Plot 10a, First Street

Response to MCC Comments – Note 01

April 2023

PL1471.2-PLA-GF-00-DR-L-001

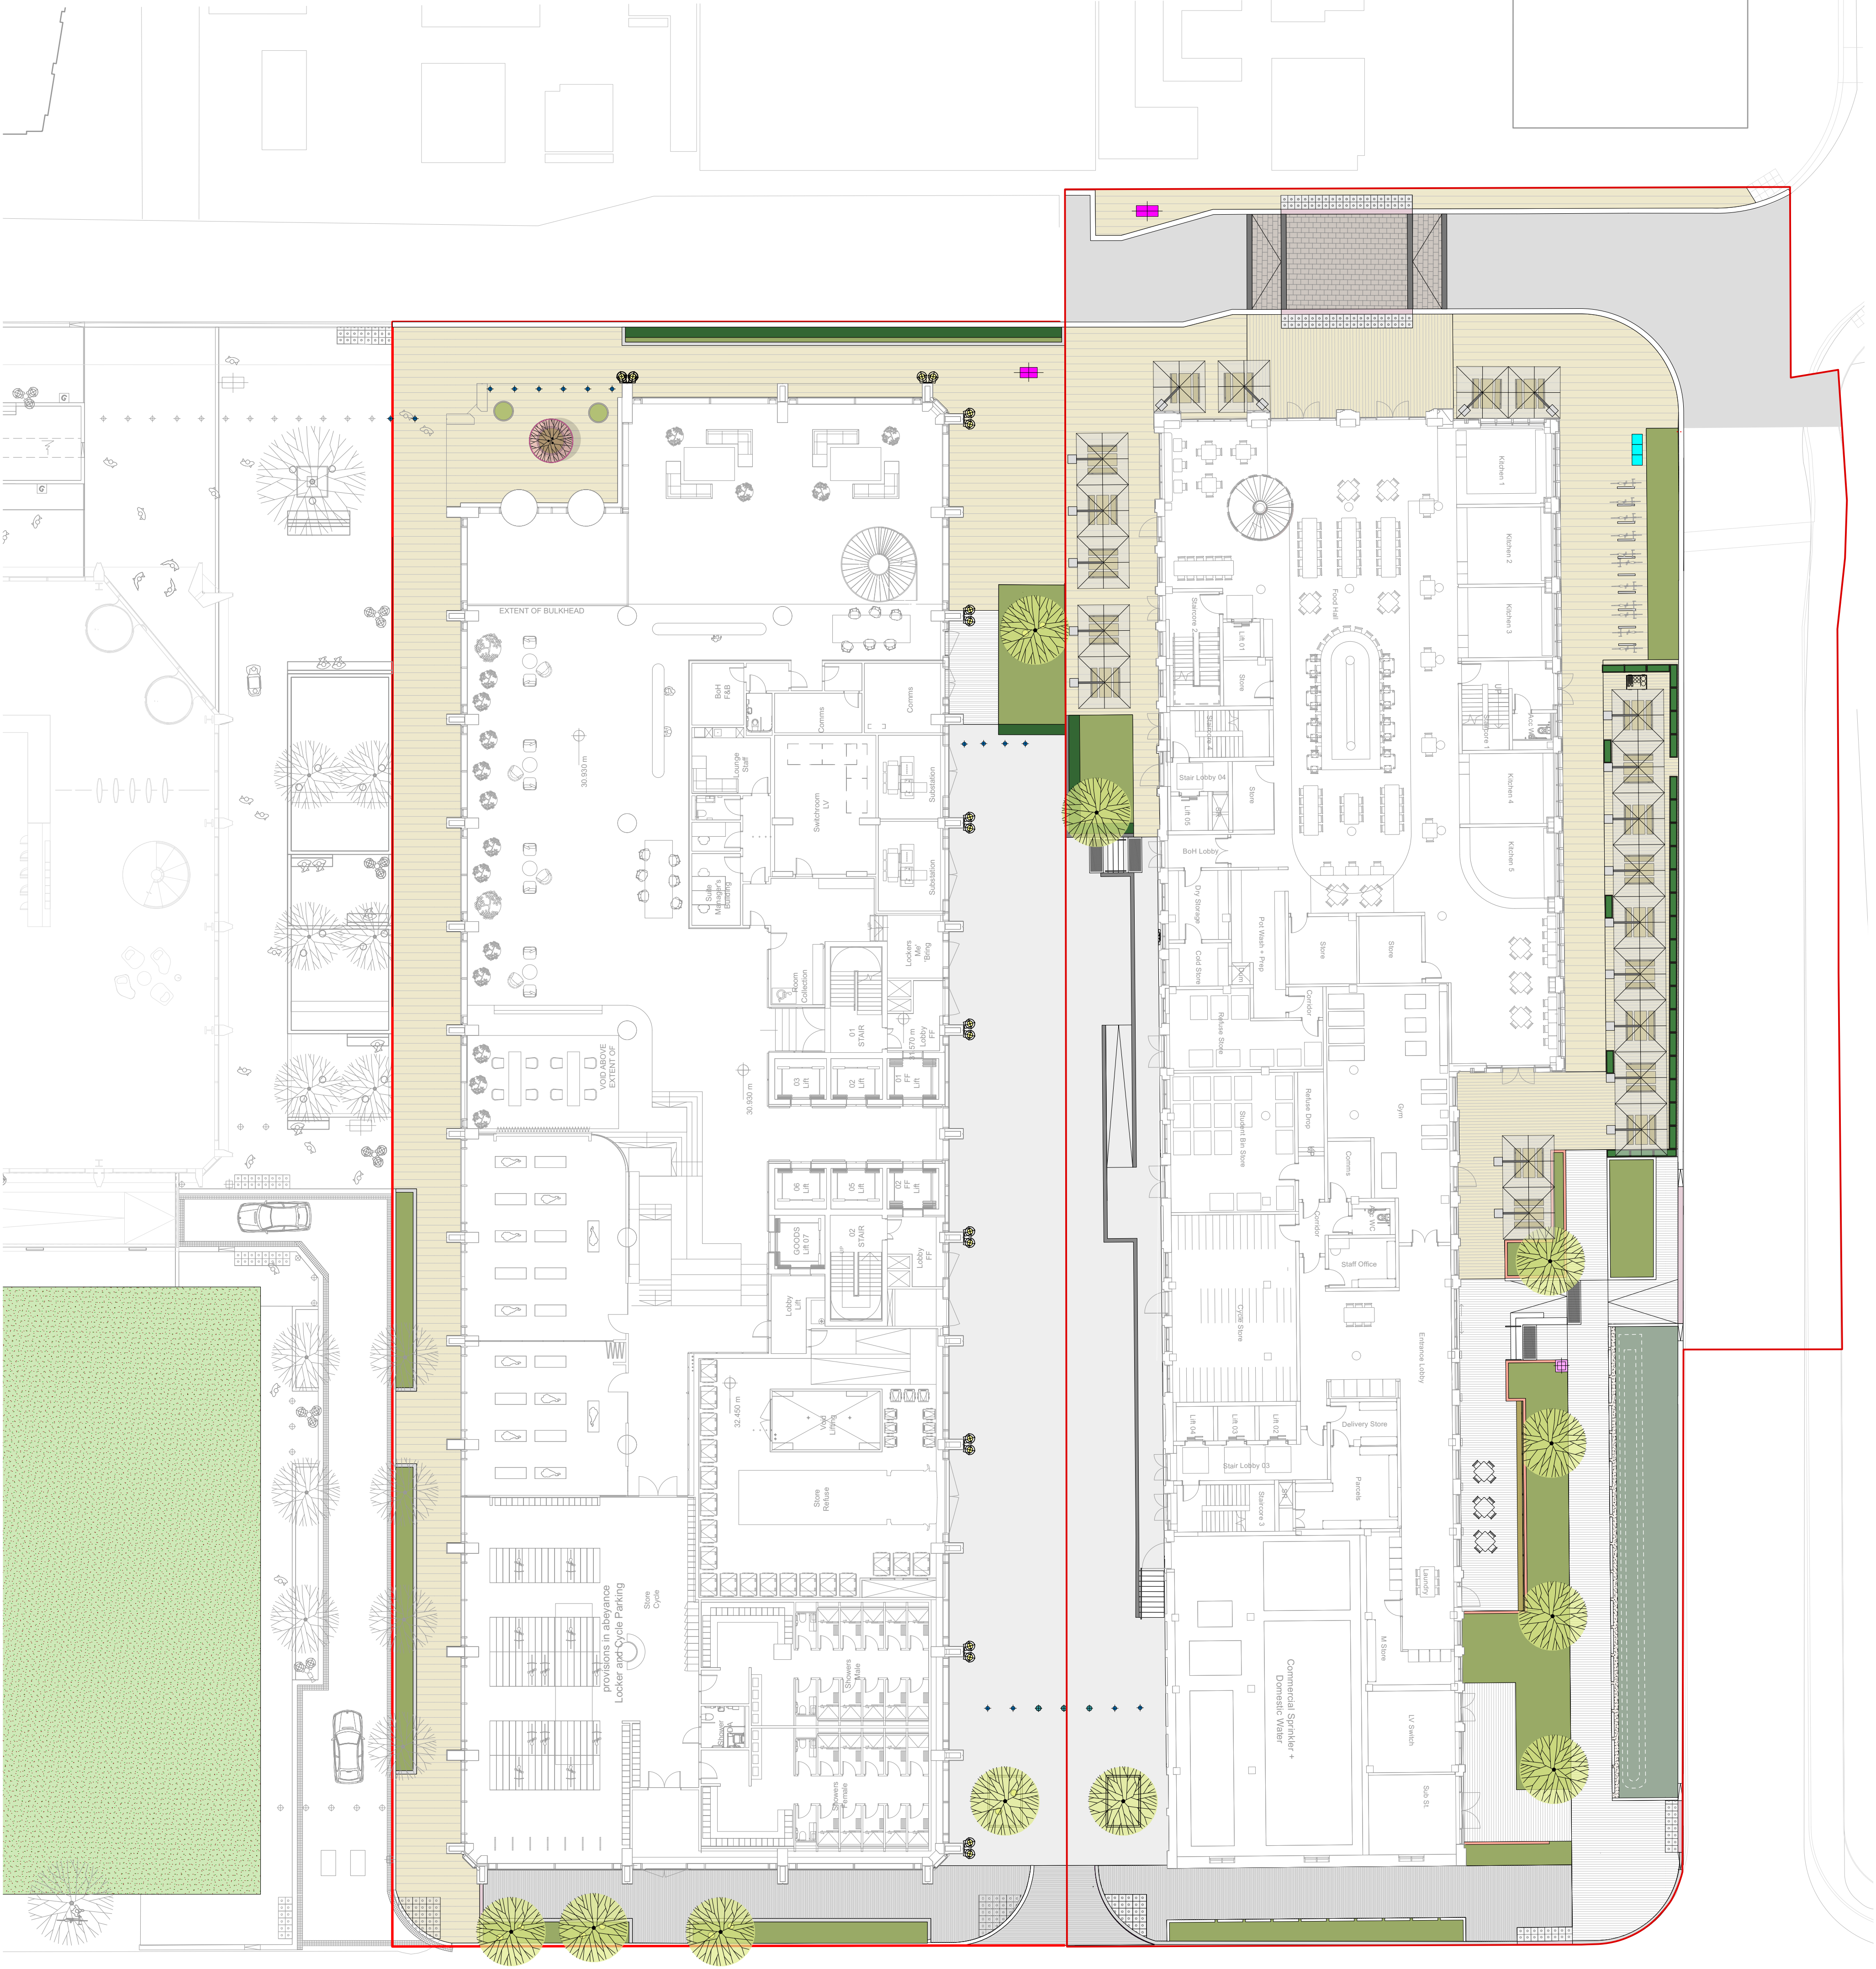
- The developer needs to demonstrate that a safe access is achievable for the interim servicing arrangements. At present the submitted plans suggest that the interim access will be within close proximity of the building edge of Plot 10a and vehicles will reverse over proposed dropped kerbs, footway and tactile paving. In order for Highways to provide a response we will need to see a proposed interim access drawing with an acceptable and achievable access radius, sight lines and swept path.

- Clear details on how the Amazon vehicles, LGVs and HGVs will access the site and be managed/monitored for the interim servicing arrangement should be provided.

For clarity the Access would be designed with a sacrificial temporary surface. This would be finished with a high quality surface once both Plot 10 buildings are complete. These works would be specified as part of the detail highway design.

In the interim scenario 2 the large vehicles and the regular vehicles will be given timed slots for access and actively managed to avoid clash. There is scope for additional ad-hoc vehicles to arrive during this period. These are not expected to stay long and there is scope for additional vehicles to arrive and not block another waiting vehicle.
